# Access Compliance Report

## Public Rights-of-Way

### (Curb Ramps)

Intersection ID: 45134	Main Street: DULIN_CREEK_BV	Cross Street: LITTLE_WHITEOAK_RD	Location: NE
ADA ID: 41A9E7F4752D	Ramp Type: PerpDiag	Initial Pass/Fail: Fail	Overall Compliance: No
Codes/Mitigation Info/Possible Solution		Field Measurements/Component Compliance

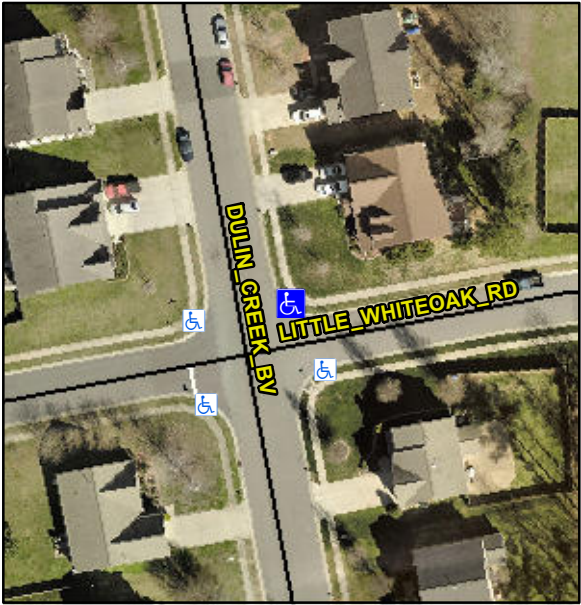
Possible Solutions:	Compliance	Description	Data	Compliance	Description	Data
	Remove & Replace Curb Ramp With Two New Directional Ramps or Equivalent.	N/A	Ramp Length (in)	48.0	Yes	Ramp Slope (%)	5.5
		No	Ramp Width (in)	47.5	No	Ramp XSlope (%)	3.1
		N/A	Flare Type LT	N/A	N/A	Flare Type RT	N/A
		N/A	Flare Slope LT (%)	N/A	N/A	Flare Slope RT (%)	N/A
		N/A	Flare Traversable LT?	N/A	N/A	Flare Traversable RT?	N/A
		N/A	Landing Length (in)	N/A	N/A	DWS Provided?	N/A
		N/A	Landing Width (in)	N/A	N/A	DWS Contrast?	N/A
		N/A	Landing Slope (%)	N/A	N/A	DWS Length (in)	N/A
		N/A	Landing X Slope (%)	N/A	N/A	DWS Full Width?	N/A
		N/A	Landing Curb? (Y/N)	N/A	N/A	DWS Offset (in)	N/A
		N/A	Shared Landing?	N/A			
		N/A	Gutter Ponding?	N/A	N/A	Gutter Slope (%)	N/A
		N/A	Gutter Lip Ht (in)	N/A	N/A	Gutter X Slope (%)	N/A
		N/A	Painted X Walk1?	No	N/A	Painted X Walk2?	No
			X Walk 1 Direction	To W		X Walk 2 Direction	To S
		N/A	X Walk 1 Width (in)	N/A	N/A	X Walk 2 Width (in)	N/A

X Walk 1 Slope (%)	1.2		X Walk 2 Slope (%)	0.8
			X Walk 1 X Slope (%)	4.3		X Walk 2 X Slope (%)	4.5
		N/A	Ramp inside XWalk1?	N/A	N/A	Ramp inside XWalk2?	N/A
<p>Surveyor Notes:</p> <p>N/A</p> <p>PROW/ADA:</p> <p>Not Found, R304.5.1, R304.5.3</p>			Road Slope (%)	4.0	N/A	Clear Space?	N/A
			Road X Slope (%)	5.3	N/A	Clear Space to XWalk (in)	N/A
		N/A	Any Obstructions?	N/A	N/A	Storm Grate/Utility Hazard?	N/A
			Obstruction Type			Storm Grate/Utility Type	
					N/A		N/A
					Yes	Surface Condition? (G/P)	Good
